Re: Calibre Consulting – 2016 North Tralee Flood Study Review

In February 2016, WMAwater carried out a peer review of the North Tralee Flood Studies (Brown Consulting, 2010) on behalf of Queanbeyan City Council. This review concluded that the 100 year ARI flow estimate determined as part of the Brown Study (2010) was suitable for use in design flood modelling. However, the review suggested that hydraulic model should be reviewed and additional survey work be carried out to incorporate into the model. This work has now been carried out and an update has been provided by Calibre Consulting in July 2016. This letter details a review of the Calibre Study (2016), undertaken by WMAwater on behalf of Queanbeyan-Palerang Regional Council.

Image 1: Overland Flow Flood Modelling Results (Depth)

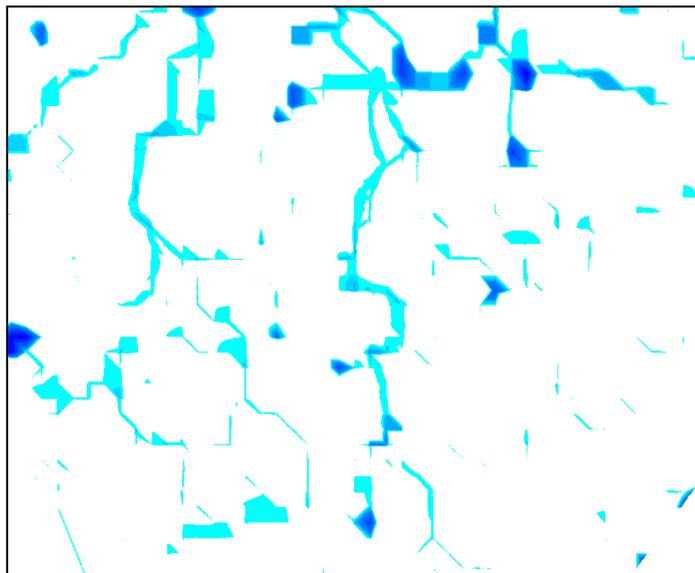
It was also noted that the Calibre Study (2016) modelled overland flow to the south of the Site. The overland flow results have not been reviewed extensively, however it is noted that on preliminary examination the results appear to be unusual, particularly in the upper reaches (see Image 1). It was noted that the flow paths appear to be gridded in a semi-linear/parallel fashion. This may indicate that there may be issues with the available DEM, presumably due to the employed tinning process. Whilst this is of only minimal issue with the current study's modelling of mainstream flood behaviour, for subsequent studies focusing on overland flow the DEM should be examined in detail and validated.

Image 2: Dense Vegetation

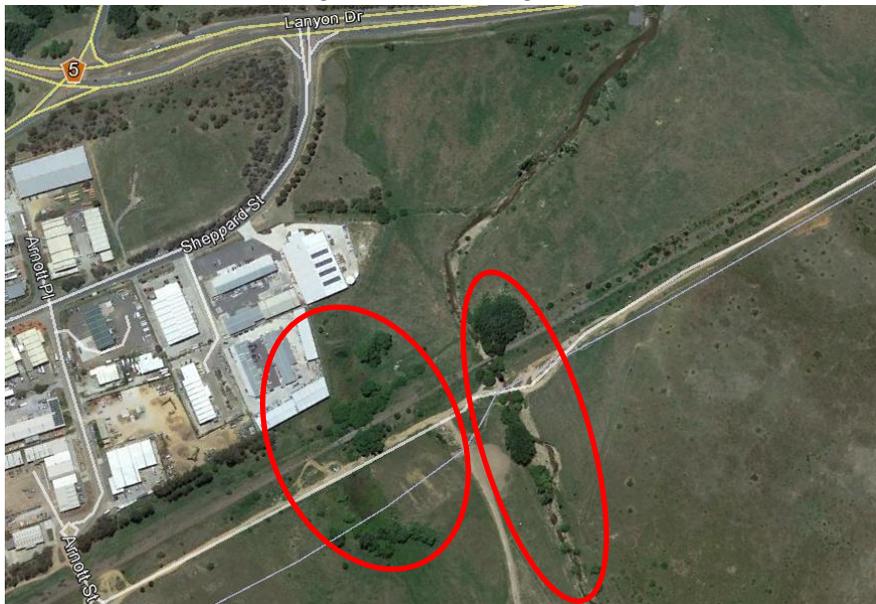
Roughness estimates impact on hydraulic characteristics such as peak flood level. The Manning's 'n' values for each grid cell should be based on vegetation and other obstructions at each location. The Calibre Study (2016) has used roughness values similar to those used in established references and other nearby studies. However, the spatial distribution of more dense vegetation types have not been modelled. In particular, riparian vegetation and vegetation close to the two railway underpasses (see Image 2) has not been considered. WMAwater have examined the vegetation density at these locations and estimate that a Manning's 'n' of 0.08 should be applied.

However, as the above mentioned vegetation is generally quite localised, it is expected that failing to model these features would not lead to widespread impacts on flood behaviour.

Image 3: Calibre Study (2016) FPA – 100 year ARI Event plus 0.5 m

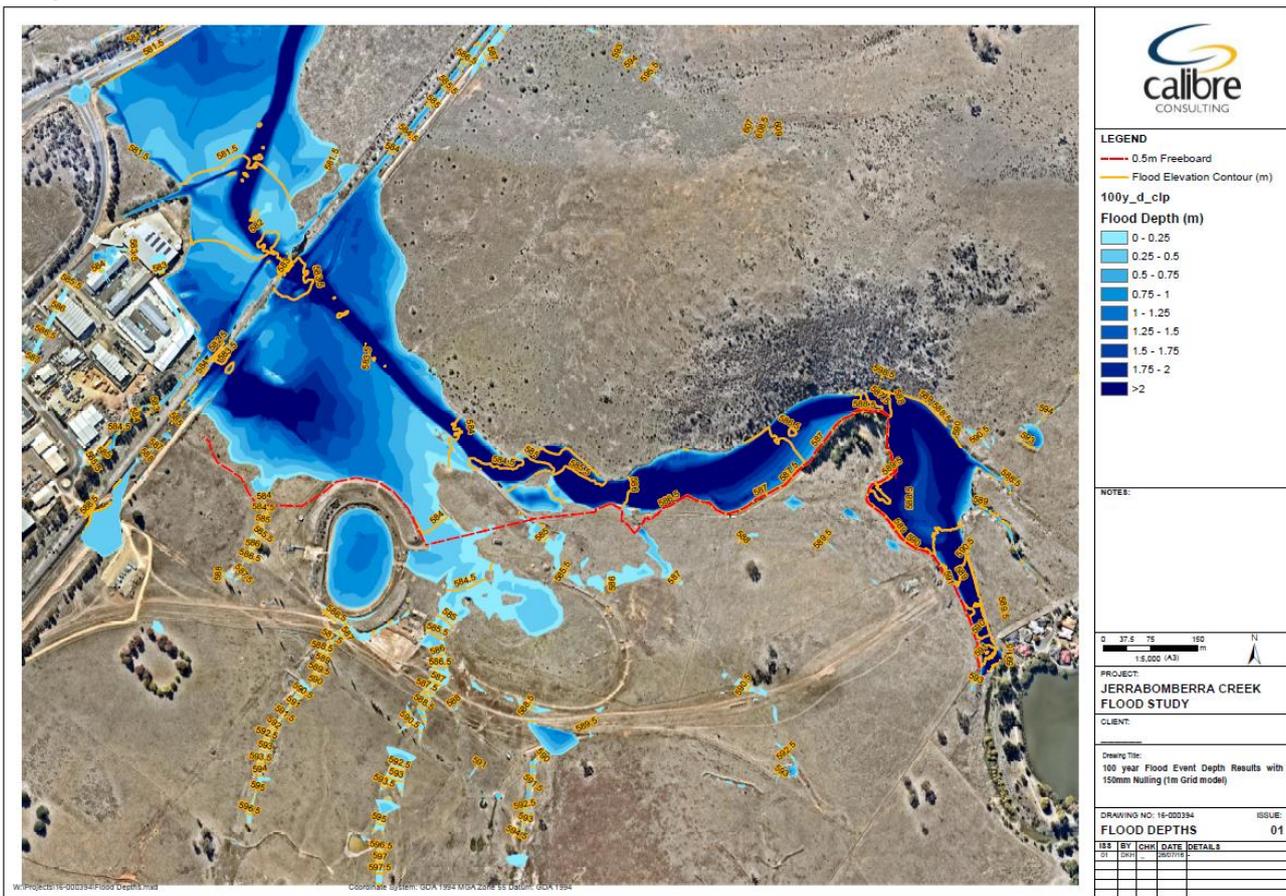
Council have requested that the Calibre Study (2016) FPA (as derived using the 100 year ARI event + 0.5 m freeboard) be examined to investigate the suitability for incorporation of this information into the draft plan for Council's LEP. The FPA extent as presented as the red line on the final page of the Calibre Study (2016) and recreated herein as Image 3, has been determined as representative of the 100 year ARI event + 0.5 m freeboard. However it should be noted that the FPA extent may need to be extended further to the north-west until the Railway embankment is met, depending on the

proposed rezoning area. Additionally, it should be noted that the FPA extent has not been determined for the northern floodplain which may be a requirement of Council.
